Review of the Denver Water Department  
Induced Seismicity Program at Strontia Springs, Colorado

William Spence  
Open-File Report 82-64  
U.S. Geological Survey

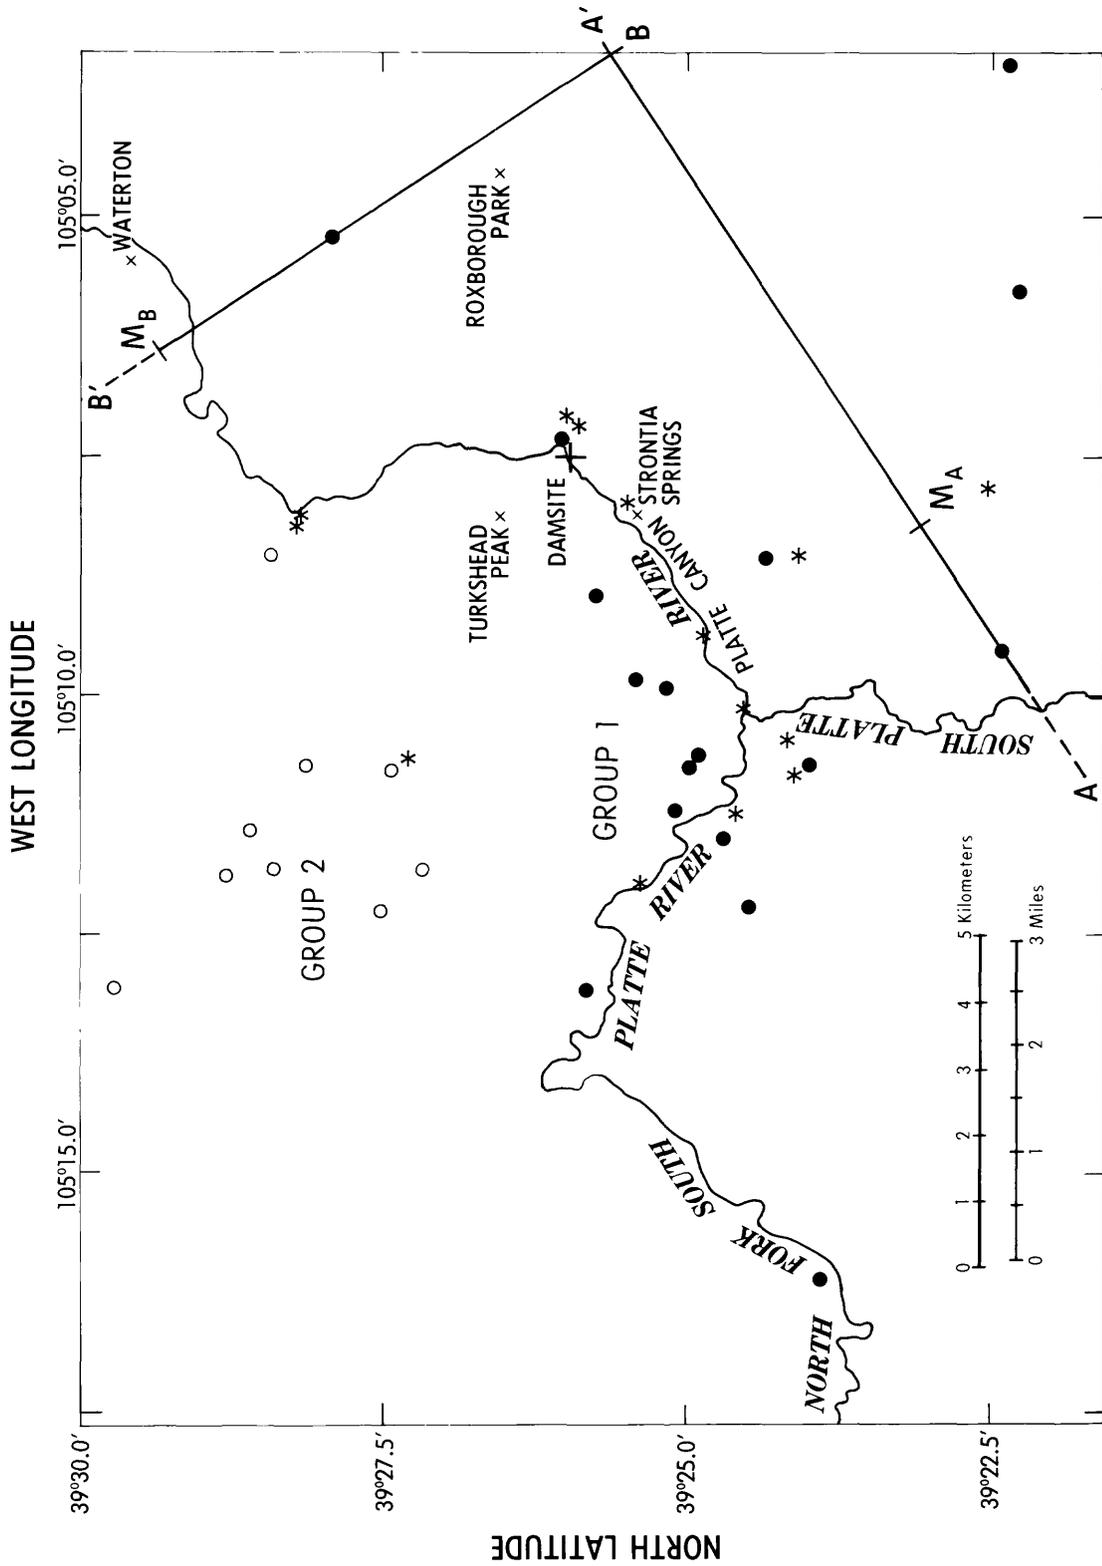
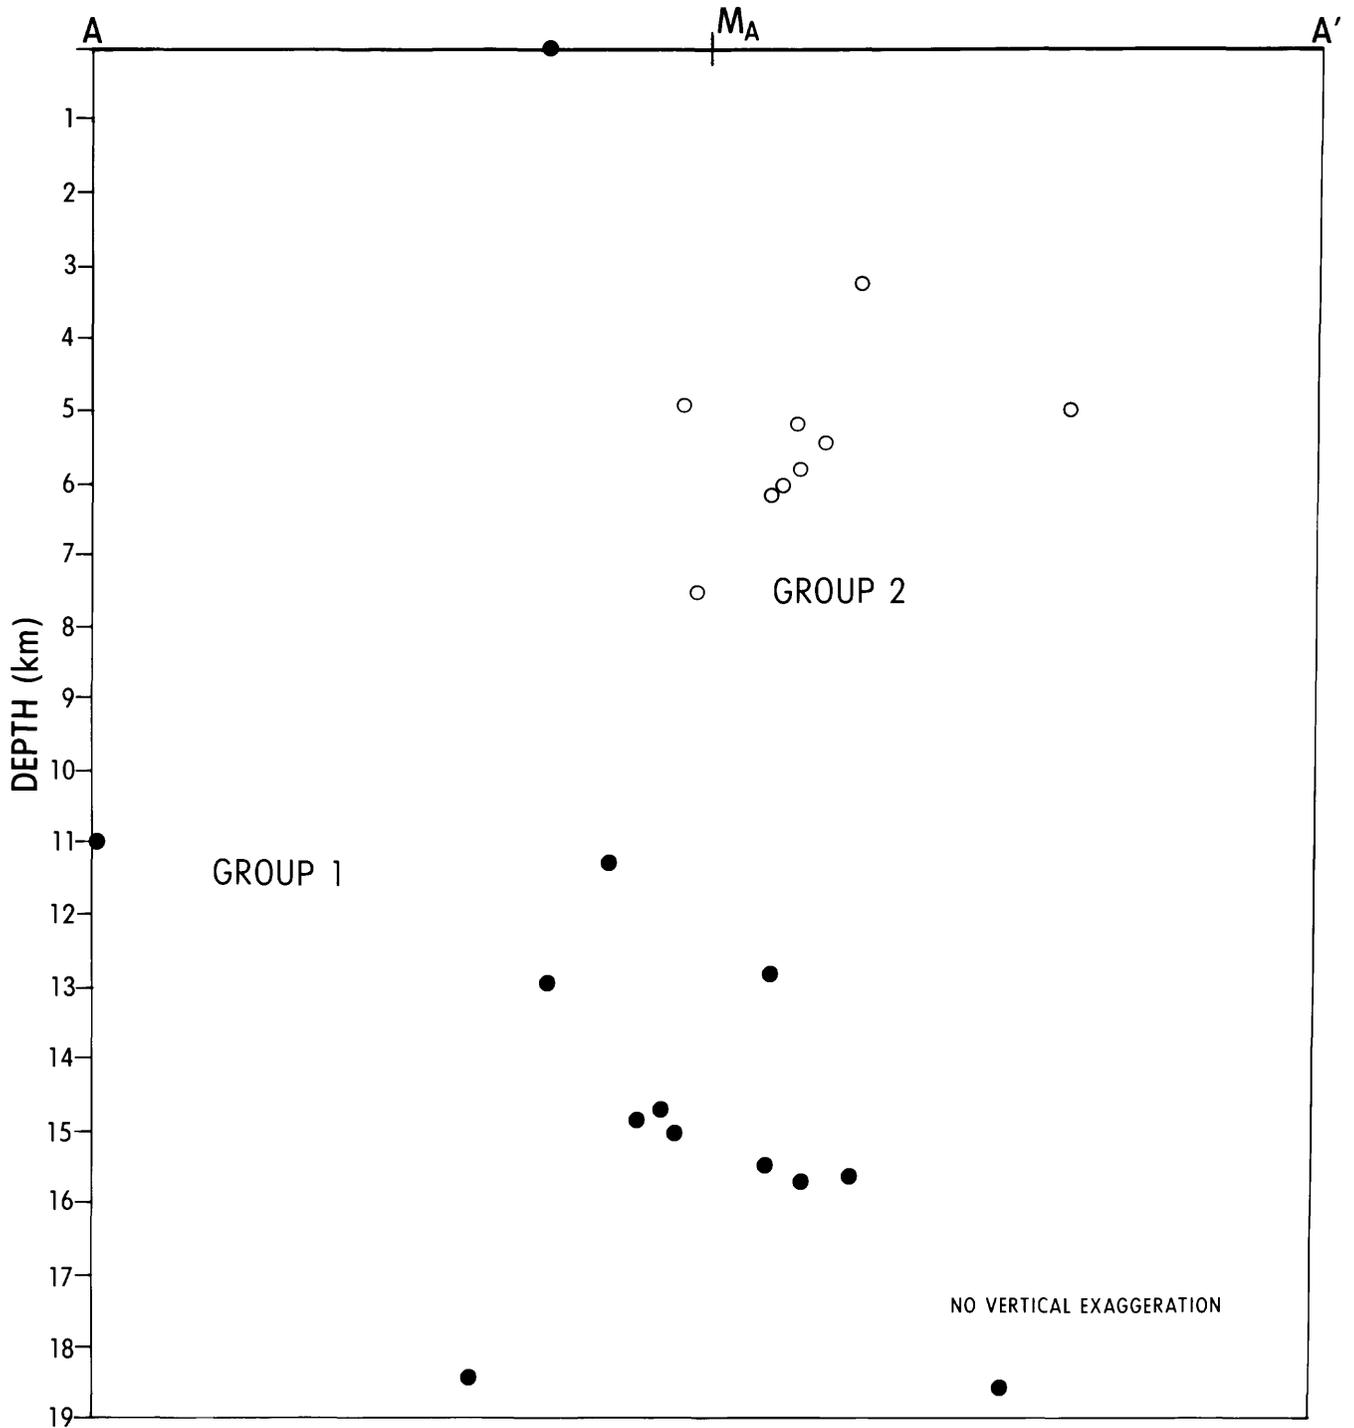
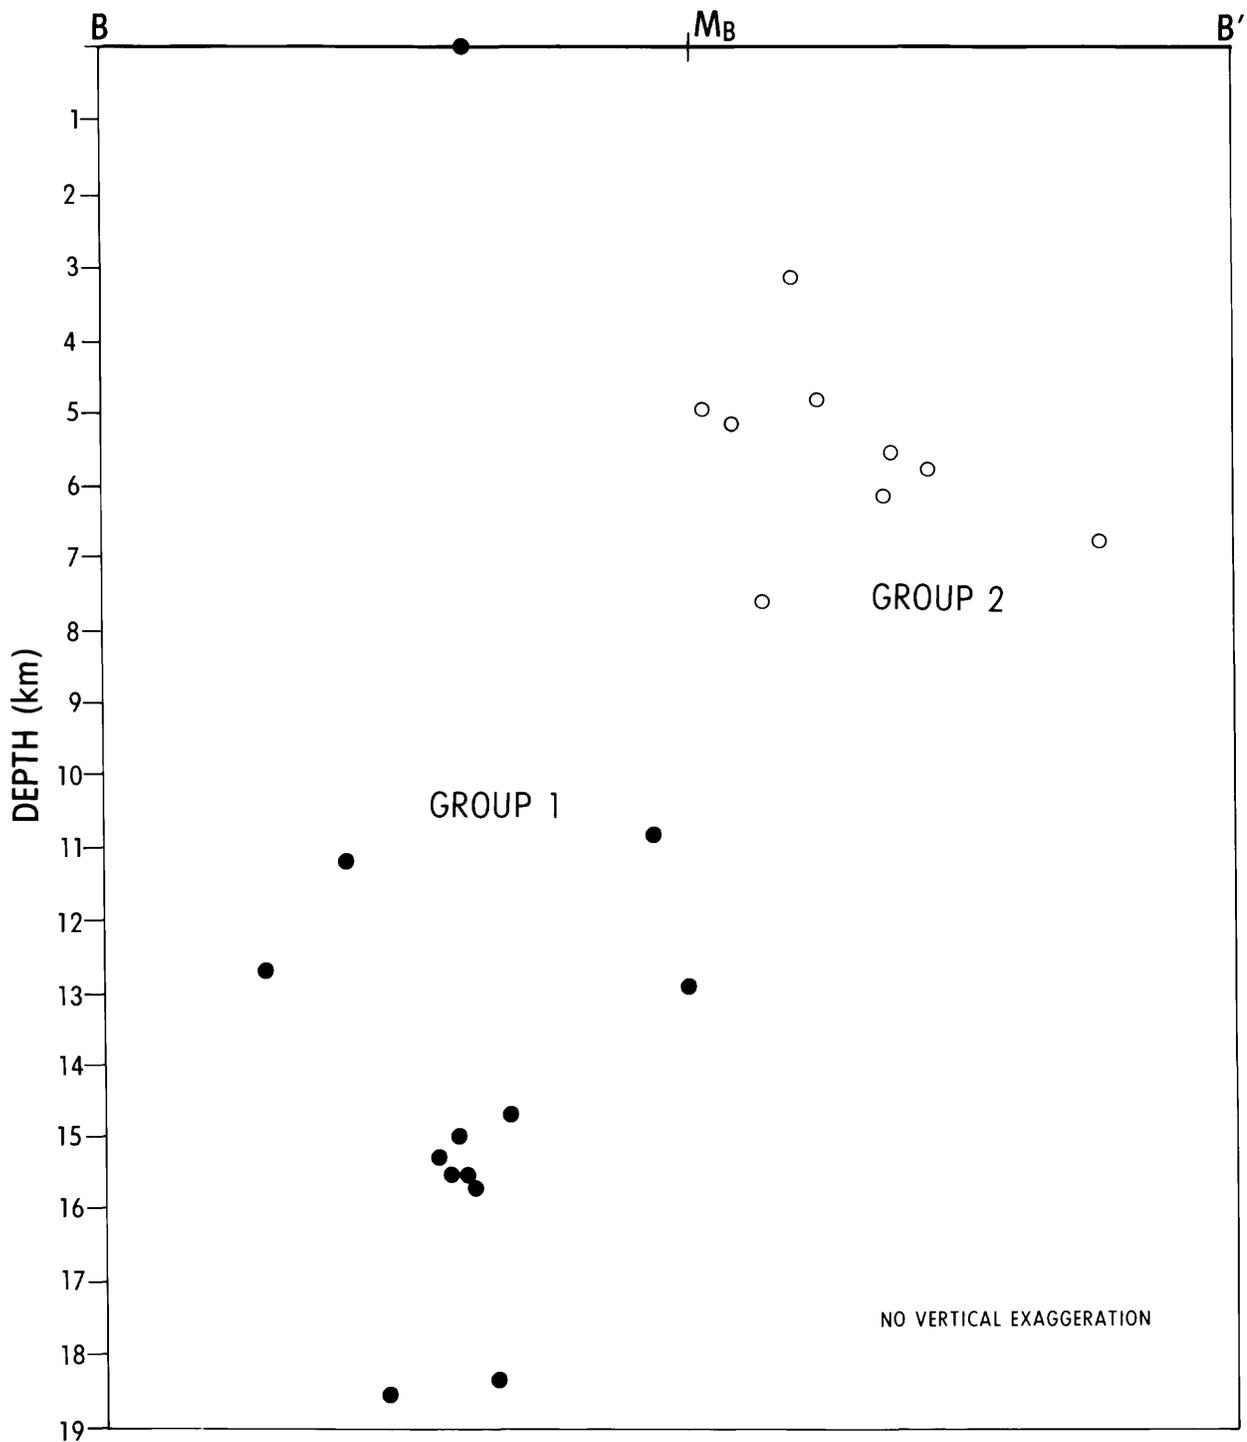
The MicroGeophysics microearthquake baseline study found two important space-time groupings of microearthquakes (figure 2). The first group is a 7 km-long trend of 13 events, that is north and subparallel to the Platte Canyon, slightly upstream from the dam site. The hypocenters of this group are generally between 11 and 16 km deep (figures 3 and 4) and the largest event has a magnitude of about +0.6. Nearly half of these events occurred during a 1-month period in February and early March 1978. The first group of hypocenters indicate a definite northeast-trending, mid-crustal lineation. These events are within the station network and have good location resolution. The second group is a cluster of 9 events, centered approximately at a point 7 km northwest of the dam site. The hypocenters of this group are generally between 3 and 8 km deep (figures 3 and 4) and the largest has a magnitude of about -0.2. Nearly half of the second group of events occurred during a one-month period in late May and early June. These events do not

There is an unambiguous spatial gap between these two groups of microearthquakes, both in their epicenters and in their depth distributions (Figures 2, 3, and 4). Likewise, these two groups of microearthquakes are strongly clustered at different time intervals. One must assume that if the high-resolution microearthquake monitoring were to be extended for an indefinite time interval that still other space-time groupings of earthquake activity would be observed. Possibly such natural activity could occur directly beneath the Strontia Springs Dam and reservoir site.
